**CONTRACT NO. DE-AC27-01RV14136 – CLOSEOUT COMMENT/RESPONSE ON
PRETREATMENT CONSTRUCTION AUTHORIZATION REQUEST**

Comment Response Form with Contractor Response
(PT-PSAR-342)

Office of Safety Regulation	OSR Review Team Questions for BNI
Question # PT-PSAR-342	Date 01/07/2003 Opened:
Place "X" if answering "yes": Limited Rights Information? ___ Team Accepted? ___	Date to Contractor: Date of Response: Date Closed: Reviewer:
Cited Reference:	
<p>SRD Safety Criterion 4.1-3 states in part, "SSCs designated as Important to Safety (i.e., Safety Design Class and Safety Design Significant) shall be designed to withstand the effects of NPH events such as earthquakes, wind, and floods without loss of capability to perform specified safety functions as the result of the NPH events."</p> <p>ASCE 4-98, Seismic Analysis of Safety Related Nuclear Structures and Commentary" Section 3.3.1(a) an implementing standard for this criterion requires, "Soil-structure interaction (SSI) effects shall be considered for all structures not supported by rock or rock-like soil foundation material"</p> <p>02-OSR-0517, Contract No. DE-AC27-01RV14136 – U.S. Department of Energy (DOE) Notice to Proceed with Constru

FIRE-WATER PIT HORIZONTAL CUT LOCATIONS

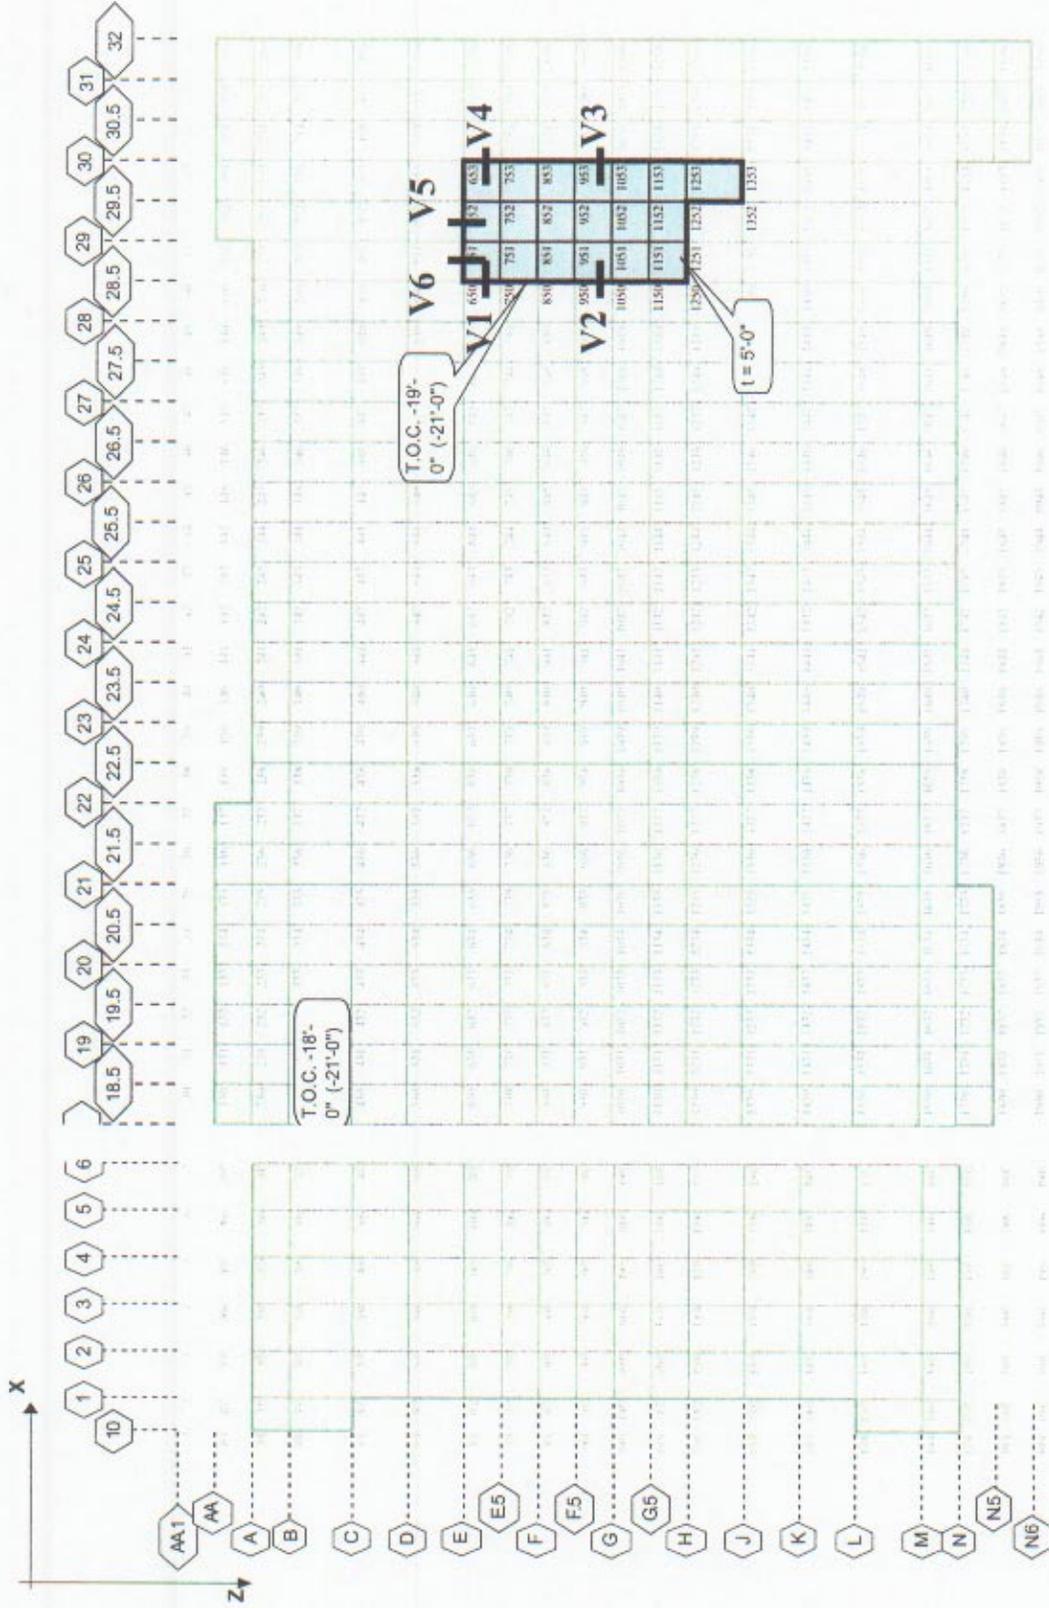
1. Item (b) asked for the soil pressures on the Firewater Pit and how they were considered for design. Additionally, how is the soil/concrete interface friction resistance on the face of the walls included in the design loads.
2. Item (e) asked how accidental torsion was considered for the basemat and walls below grade.
3. The second part of Item (a) asks: "If the SSI loads exceed the design loads, how are the higher SSI loads accounted for in representing the demand?"

The two portions of the firewater pit that were examined to assure that the loads were properly bounded. First, the horizontal interface joint between the vertical pit walls and the bottom face of the foundation mat is evaluated. This is to make sure that the total design shear load/stress at the interface is greater than the resulting shear load/stress at the interface from the SSI analysis. The results are presented in the attached tables. The shear loads at the horizontal interface of the Firewater Pit to the basemat were evaluated for both the north-south and east-west directional loading. The shear load at this interface is parallel to the wall. The shear loads have two components, the directional loading parallel to the wall (major component), and the directional loading normal to the wall (minor direction). The directional load parallel with the wall is combined with 40% directional load normal to the wall. The results are presented in Tables 1 and 2. When the GTSTRUDL/SSI Ratio is greater than 1, it is indicative that the design load used for the analysis is conservative.

Second, the GTSTRUDL design out of plane moments in the walls below grade are compared to the resulting out of plane moments from the SSI analysis. These are the same tables presented in reference 6 with the modified data from the latest runs added. Where the ratios of the SSI loads exceeded GTSTRUDL loads, adjacent wall cuts with similar reinforcing and wall thicknesses were examined to see if higher GTSTRUDL loads were used. If so, the load ratio was made with the higher adjacent design load. Since the design bounded both, the second ratio is indicative of the level of design capacity in the wall section. In addition, the representative D/C ratio of the total load from reference 2 for that portion of the wall is shown as well to see the level of demand in the wall. The Out of Plane Moment Comparison Results are presented in attached tables and figures. When the GTSTRUDL/SSI Ratio is greater than 1.2, it is indicative that the design load used for the analysis is conservative.

The soil pressures on the firewater pit were not explicitly determined from the SSI analysis using the pressure surfaces as they were for the main pits and tunnels. The soil/concrete interface shear force was not explicitly considered in the results of the SSI analysis either. To assure that the existing design bounded these loads, a comparison was completed between the explicit loads on the firewater pit from the SSI analysis (reference 1) and the loads taken from the static STRUDL model (reference 3) that were used in the wall design (reference 2).

The only logical method to demonstrate that the design methods of reference 2 used adequate design loads is to compare the shears and bending moments used in the design to the shears and bending moments directly from the SSI model. This is the methodology used previously in reference 6. Additionally, to account for the accidental torsion concern from Item (e), the comparison will utilize 1.2 load factor on the new SSI loads.

The results of the evaluation of Item 1 show that the design loads exceed the resulting loads from the SSI analysis. In the locations where the direct load comparison ratios fall below unity, a review of the actual design calculation D/C ratios demonstrate large design margins.
